Update to Alternative Specification to OCL Inductance to Control 100BASE-TX Baseline Wander

G. Zimmerman, C. Pagnanelli
Solarflare Communications
6/4/08

25.4.x Alternative to 9.1.7 Worst case droop of transformer

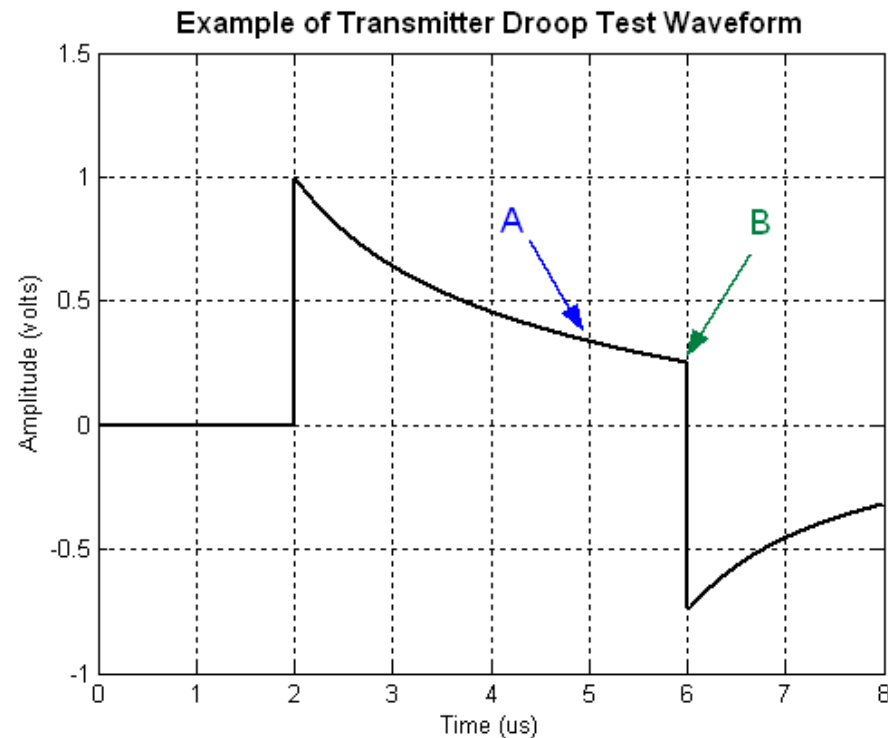
- Wording is based on 1000Base-T droop requirement (40.6.1.2.2)
- Addition to Clause 25.4, Specific Requirements and Exceptions:

A PHY that does not meet the OCL requirement of paragraph 9.1.7 of ANSI 263-1995 shall meet the following maximum output droop requirement. The magnitude of the positive voltage of the transmit droop test waveform at point B, as defined in Figure X-X, shall be greater than 87% of the magnitude of the positive voltage of the waveform at point A. These measurements are to be made while transmitting the droop test pattern and observing the differential signal output at the MDI. Point A is defined as the point exactly 1 us before point B. Point B is defined as the point just prior to where the waveform undergoes a negative transition in voltage as indicated in Figure X-X.
